ADDENDUM NO. 1

April 14, 2022

YOST ELEMENTARY SCHOOL ADDITIONS AND RENOVATIONS Chesterton, IN 46304

Addendum One (AD.01) to the drawings and specifications prepared by Gibraltar Design for **New Yost Elementary School** for Duneland School Corporation, Chesterton, Indiana.

FIRST FLOOR DEMOLITION PLAN

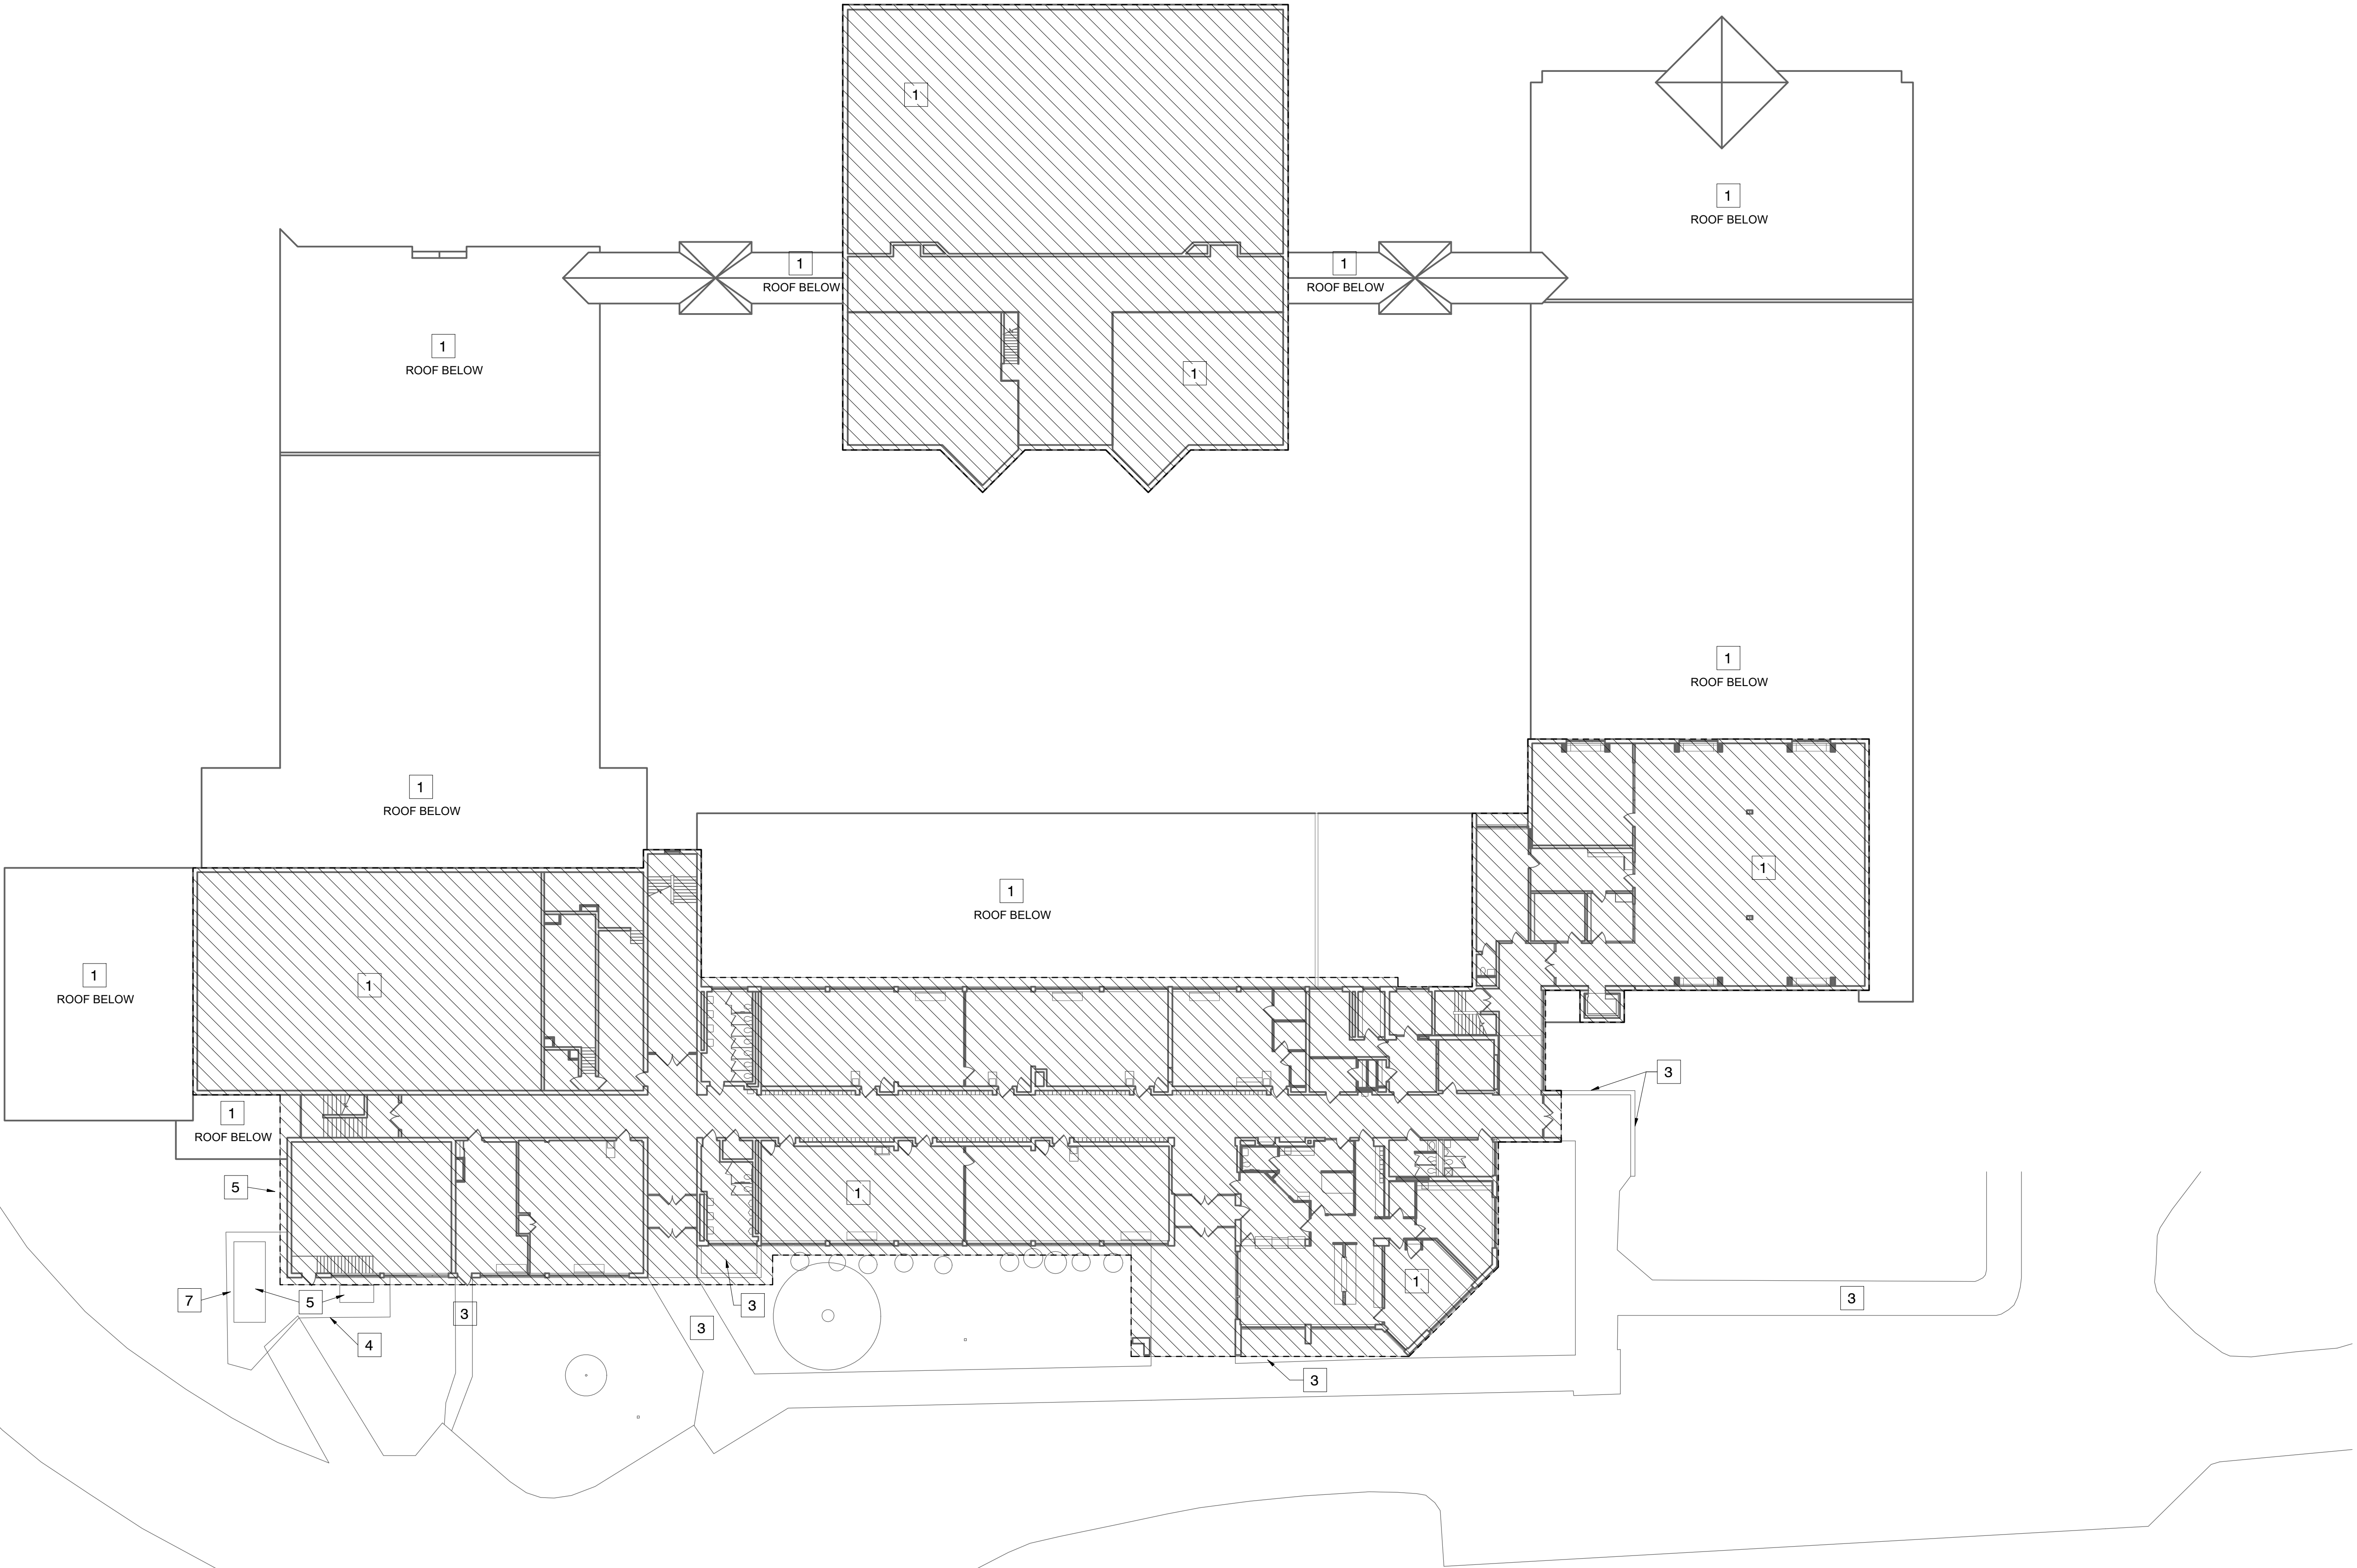
4. Sheet AD-001 and AD-002

- A. Refer to two revised full size drawings, included in this Addendum, for the following revisions:
1. Revise Note 1 to read: "Remove existing building from roof to bottom of existing footing complete. All utilities to be cut and capped at the edge of the existing portion of the building to remain."
 2. Revise Note 6 to include "Verify exact location in field."

UNIT "A" ARCHITECTURAL FIRST FLOOR PLAN

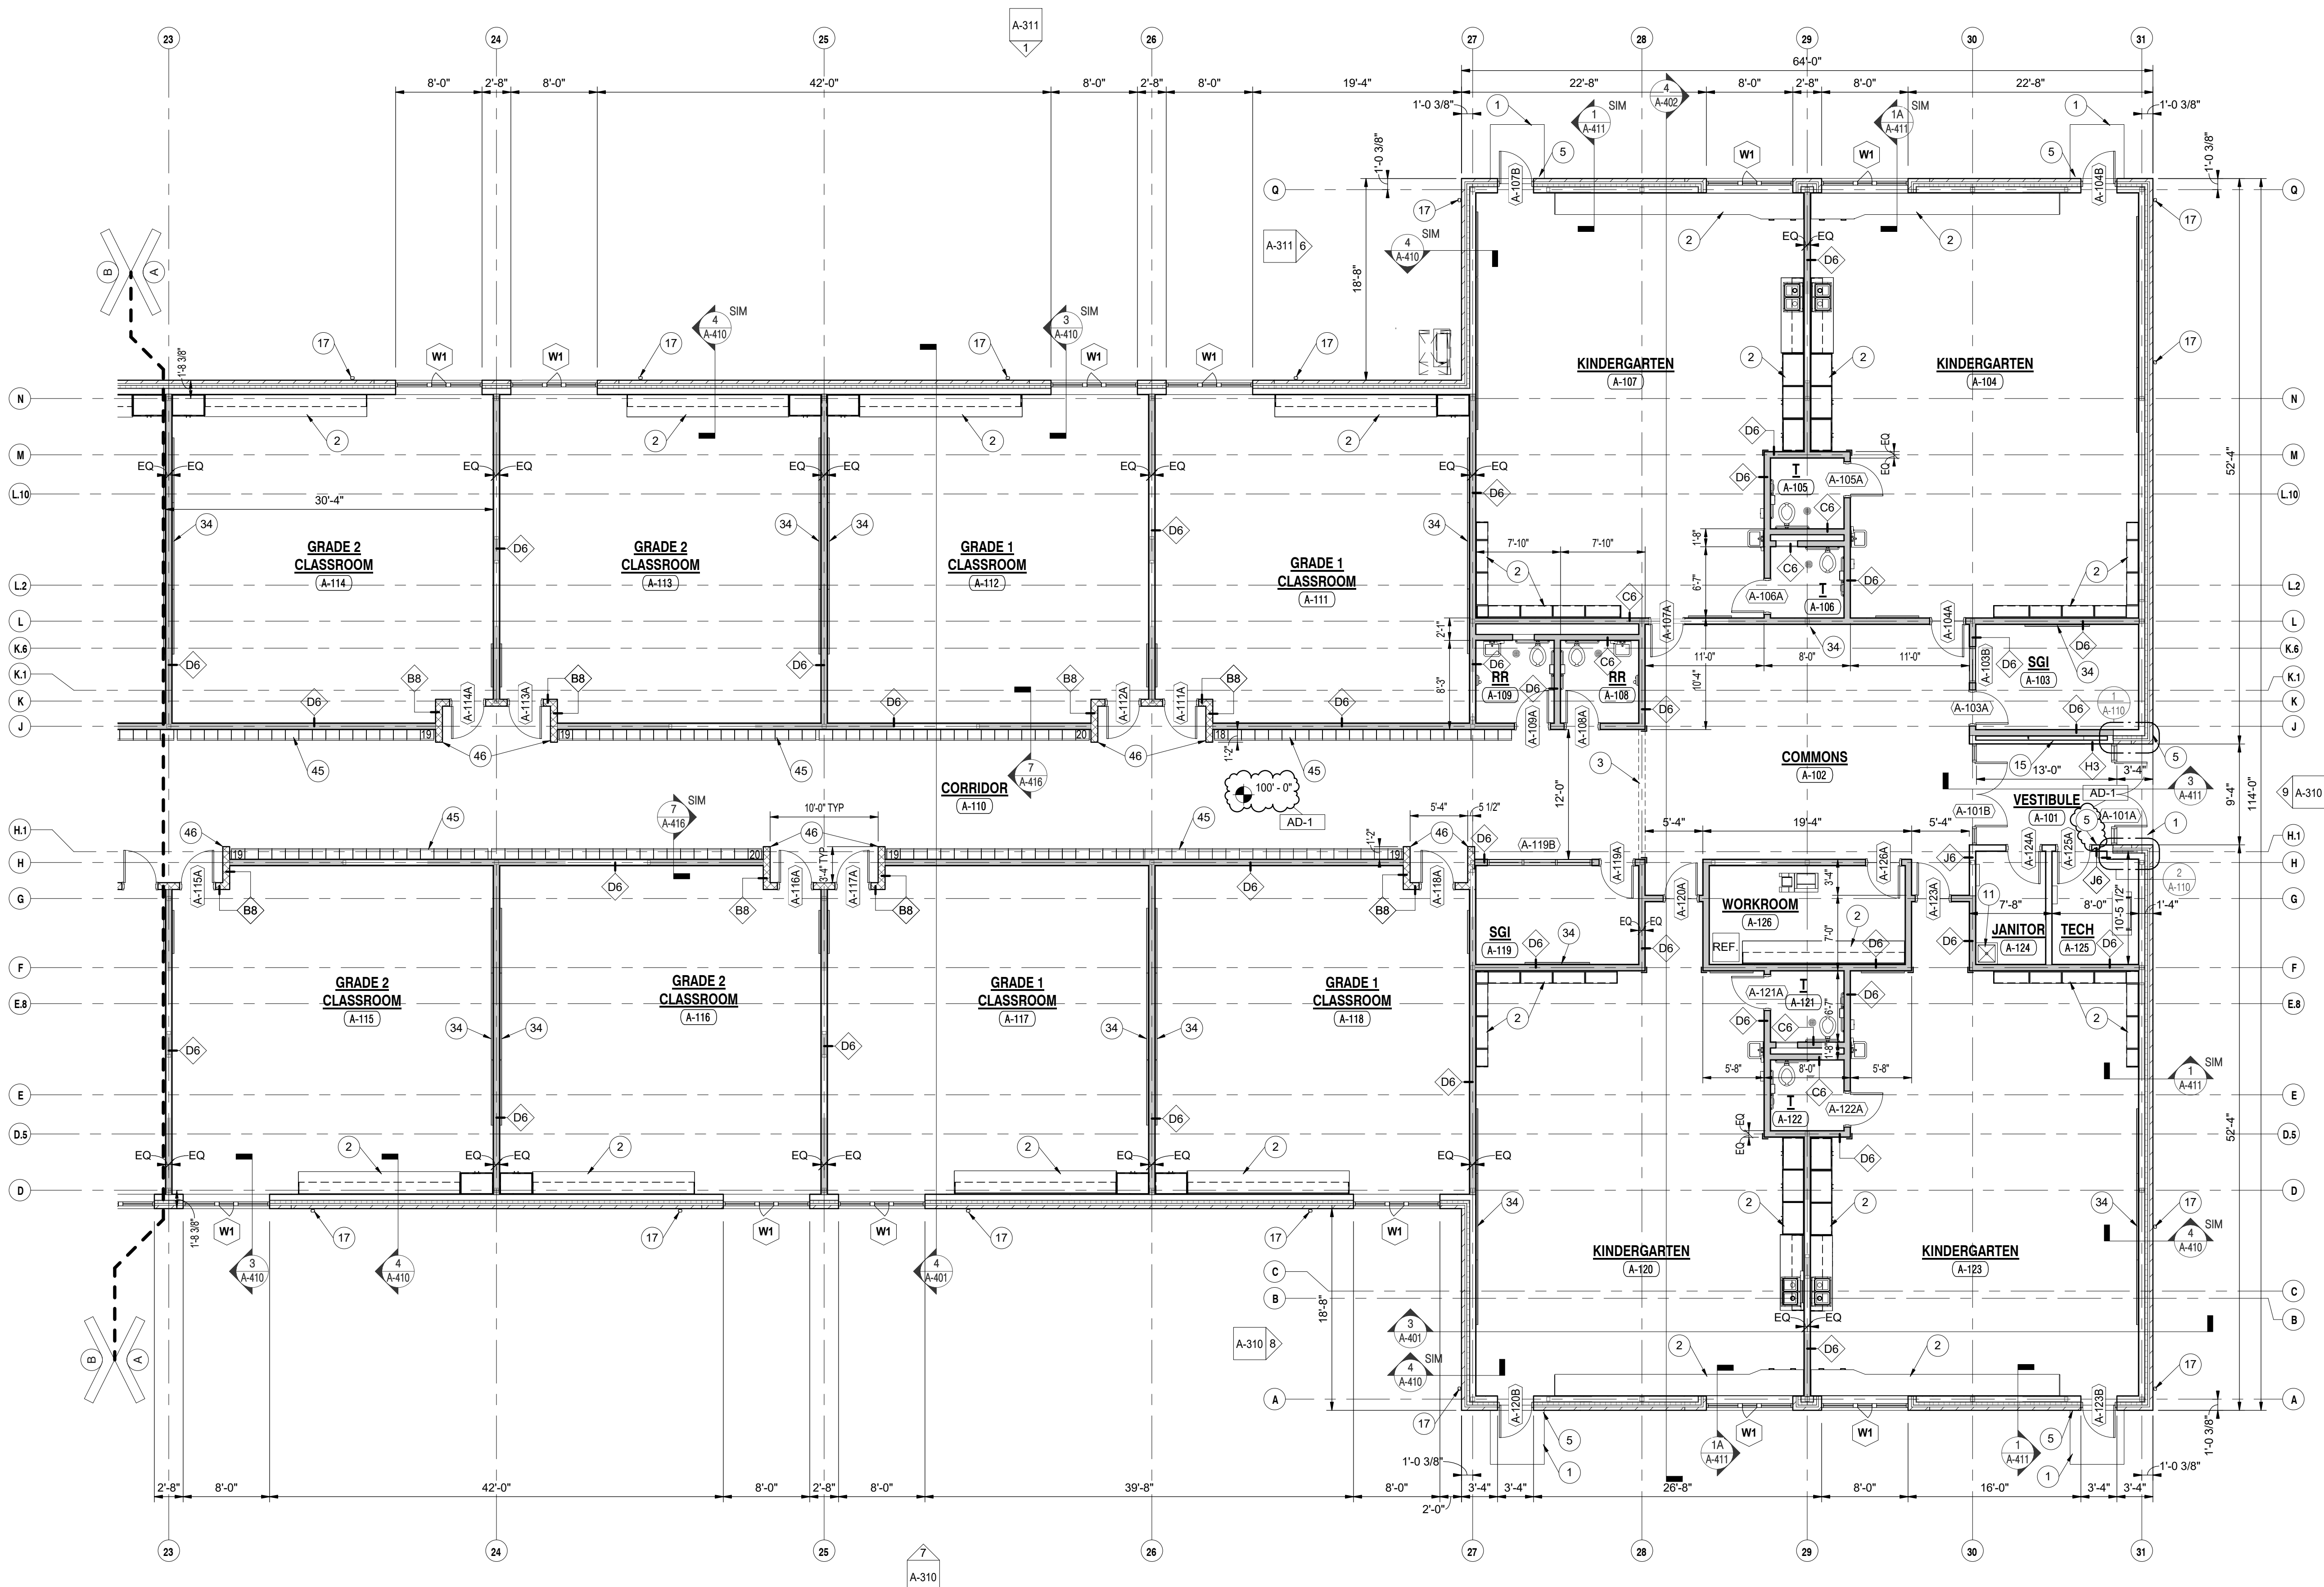
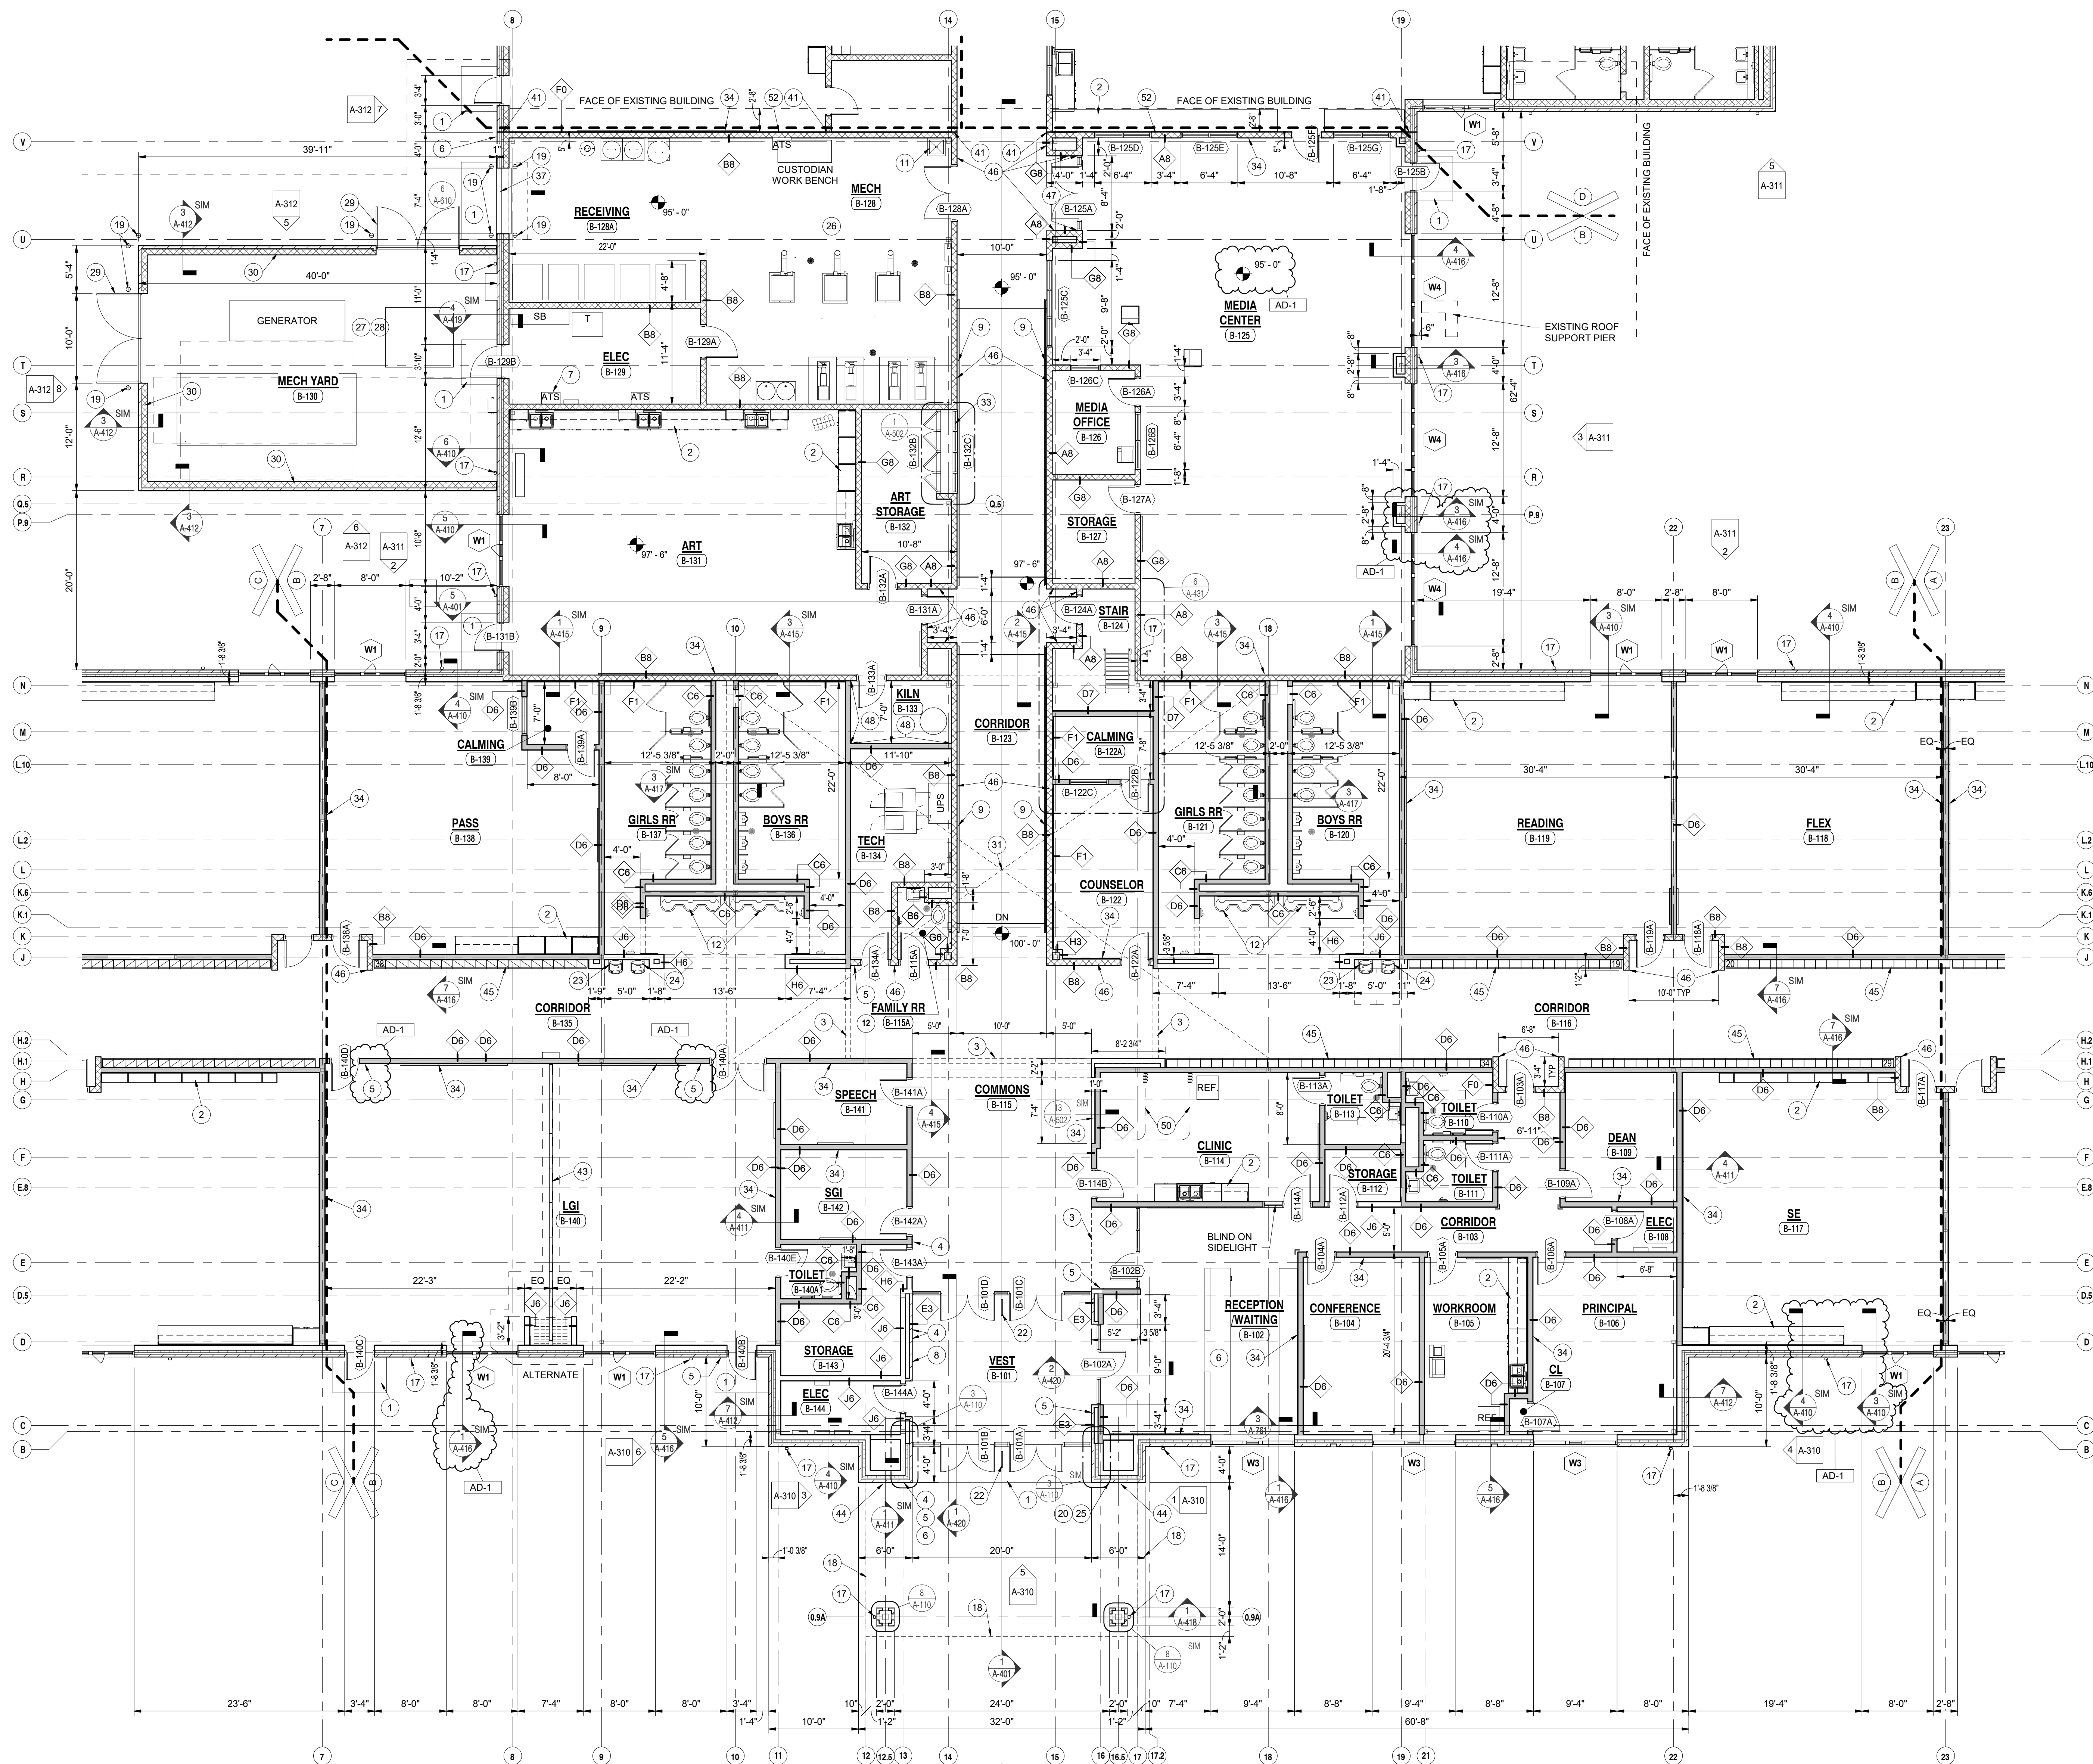
5. Sheet A-101

- A. Refer to revised full size drawing, included in this Addendum, for the following revisions:
1. Add Note 5 to Door A-125A.
 2. Add floor elevation to Corridor A-110.
